47 Rudall Crescent ref: 2017/6994/P

<b>Delegated Report</b>		<b>Analysis sheet</b>	<b>Expiry Date:</b>	<b>14/02/2018</b>
<b>(Members Briefing)</b>		N/A	<b>Consultation Expiry Date:</b>	<b>15/02/2018</b>
<b>Officer</b>			<b>Application Number(s)</b>	
Matthias Gentet			2017/6994/P	
<b>Application Address</b>			<b>Drawing Numbers</b>	
47 Rudall Crescent LONDON NW3 1RR			Refer to draft decision notice	
<b>PO 3/4</b>	<b>Area Team Signature</b>	<b>C&amp;UD</b>	<b>Authorised Officer Signature</b>	
<b>Proposal(s)</b>				
Erection of a two storey rear extension at lower and ground floor level with new balcony, glass balustrade and access stairs, height increase of existing side boundary timber fences and associated landscaping to dwelling (Class C3).				
<b>Recommendation(s):</b>		<b>Grant Conditional Permission</b>		
<b>Application Type:</b>		<b>Householder Application</b>

Proposal: Erection of a two storey rear extension at lower and ground floor level with new balcony, glass balustrade and access stairs, height increase of existing side boundary timber fences and associated landscaping to dwelling (Class C3).

### Planters/Landscaping/Fencing

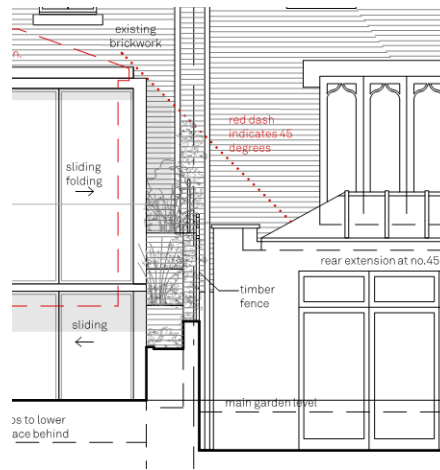
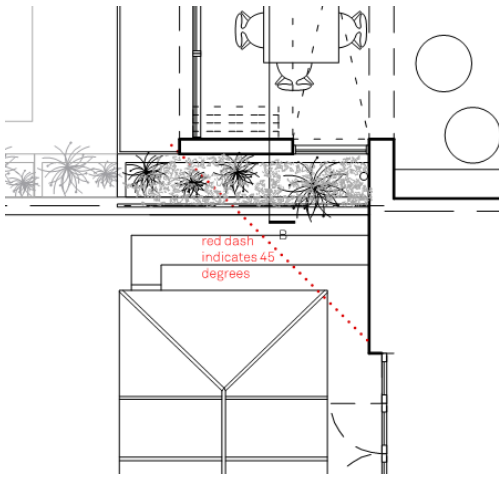
- 4.11 The proposed extension is to be flanked by 'paddock' style brick planters on 4 'espalier' levels that are to extend beyond the bottom of the timber steps leading to the upper ground floor. They would re-instate/replace the vegetation lost from the raised bed (to be disposed of) as well as compensate for a heavily hard landscaped garden area.

- 4.12 Associated landscaping would comprise of a lower terrace area and plant bed 4.3m in width by approximately 2.5m in depth and 0.6m below the main garden level. The planters would also encase the lower terrace area and new planting bed.
